# 1 Comment

2 D2.3 (#111, #131, #181, #322, #214, #333, #369).

$$0 < R_{PSE\_max} \leq \begin{cases} 2.182 \times R_{PSE\_min} - 0.040 & \text{for Class 5} \\ 1.999 \times R_{PSE\_min} - 0.040 & \text{for Class 6} \\ 1.904 \times R_{PSE\_min} - 0.030 & \text{for Class 7} \\ 1.832 \times R_{PSE\_min} - 0.030 & \text{for Class 8} \end{cases} \quad 145-15$$

32 **Figure 145-22—PSE PI unbalance specification and E2EP2PRunb**

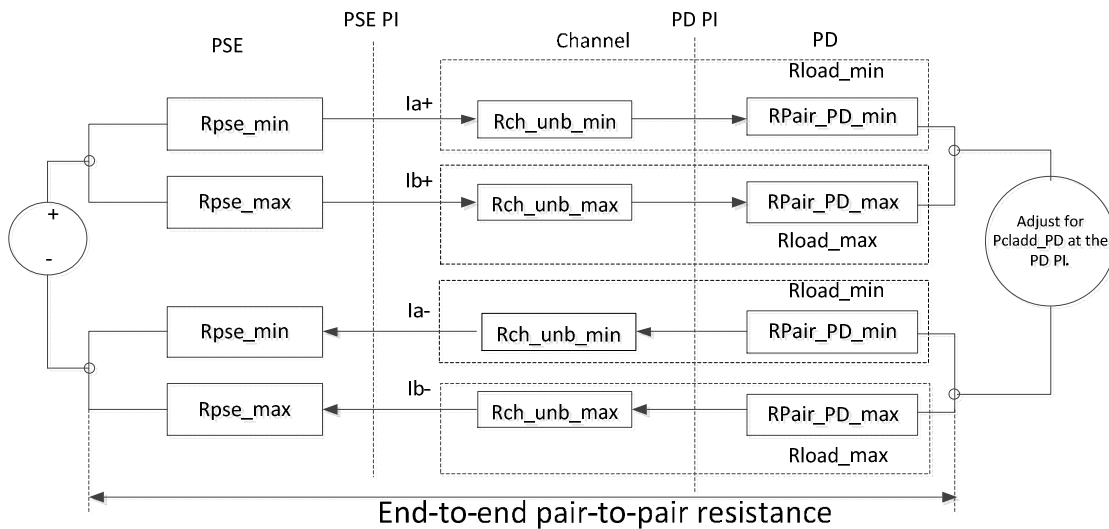
How can that be true ? RChan-2P is the loop resistance of a positive and negative pair. RChunbmin and max are for the same polarity. This sentence needs to go.

Figure 145A-1—Direct measurements of effective R<sub>PSE\_max</sub> and R<sub>PSE\_min</sub>

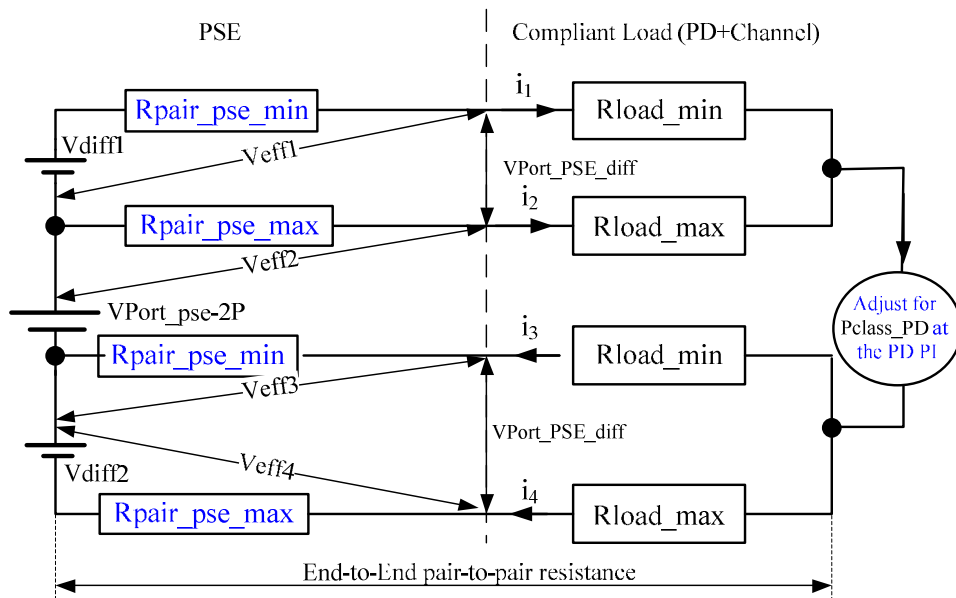
32 [RPSE<sub>min</sub> and RPSE<sub>max</sub> values respectively may be diferent than Rpair\\_pse\\_min and Rpair\\_pse\\_max](#)  
33 [values.](#)

35 **Update Figure 145A-1as follows:**

36 **Change Rpair<sub>min</sub> to Rpair\_pse\_min**

37 **Change Rpair<sub>max</sub> to Rpair\_pse\_max**

16  
17 **Figure 145-34— $I_{Con-2P}$  and  $I_{Con-2P-unb}$  evaluation model**

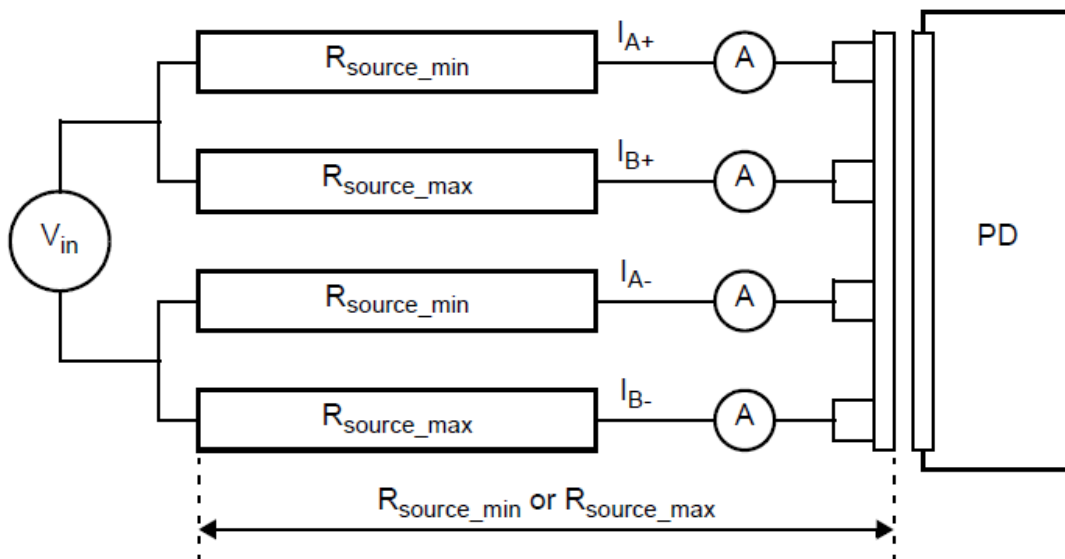
24 There is a comment on this, let's  
25 handle it in that comment.  
You refer an evaluation model that isn't  
defined anywhere.

18 [Note 1 was changed to address comment #322. Note 2 cannot be changed]

19 NOTE 1—Rsource in Figure 145-34 includes the connecting hardware resistance  $R_{con}$  of  
20 the evaluation model to the PD which is the connection resistance at the PD. The maximum  
21 recommended value is  $R_{con}$  value is 0.02  $\Omega$ .

Figure 145X-1—PD resistance unbalance elements overview

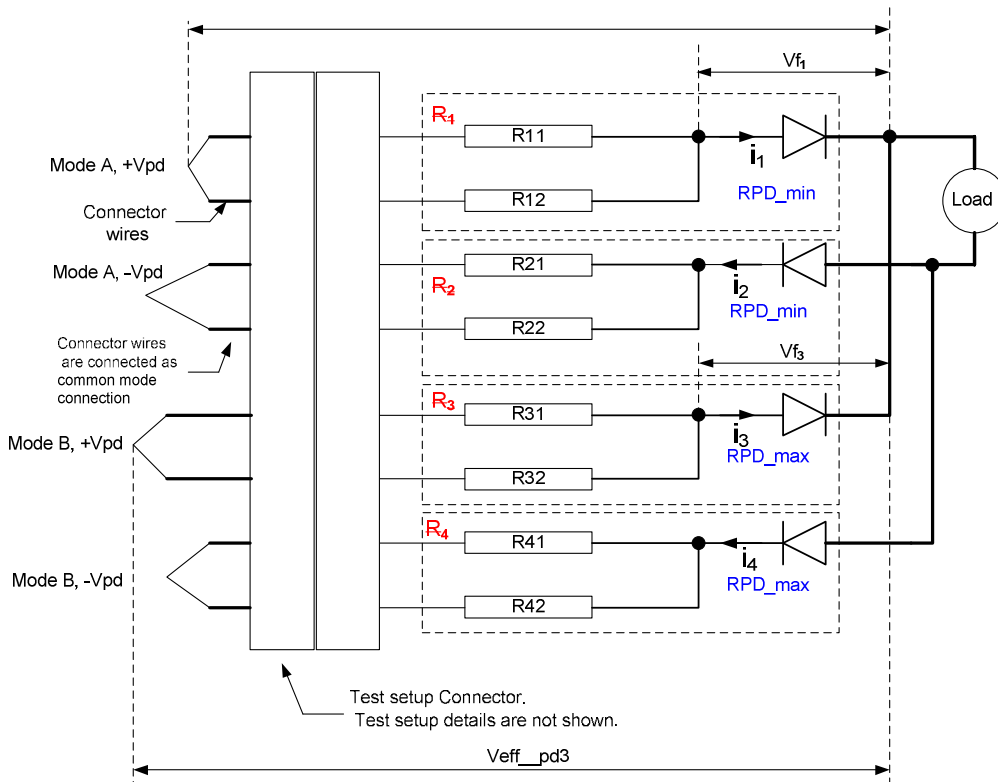
-The following is darshan\_05\_0116Rev005.pdf with new updates for D2.3 regarding using RPD\_min/max instead of Rpair\_PD\_min/max in the text and in the drawings.

- 1
- 2 -Copy the following text and drawing into Annex 145X (used to be Annex 33A.5 in D2.2).
- 3 -Approved Changes in Figure 145X-1 from D2.2 to D2.3 are marked with RED color.
- 4 -New Changes in Figure 145X-1 from D2.3 to next draft are marked with BLUE color.
- 5

RPD\_max and RPD\_min represent PD common mode input effective resistance of pairs of the same polarity.

Common mode effective resistance is the resistance of two conductors of the same pair and their other components connected in parallel including the effect of PD pair-to-pair voltage difference of pairs with the same polarity (e.g. Vf1-Vf3). The common mode effective resistance  $R_n$  is the measured voltage  $V_{eff\_pd\_n}$ , divided by the current through the path as described below and as shown in the example in Figure 145X-1, where  $n$  is the pair number.
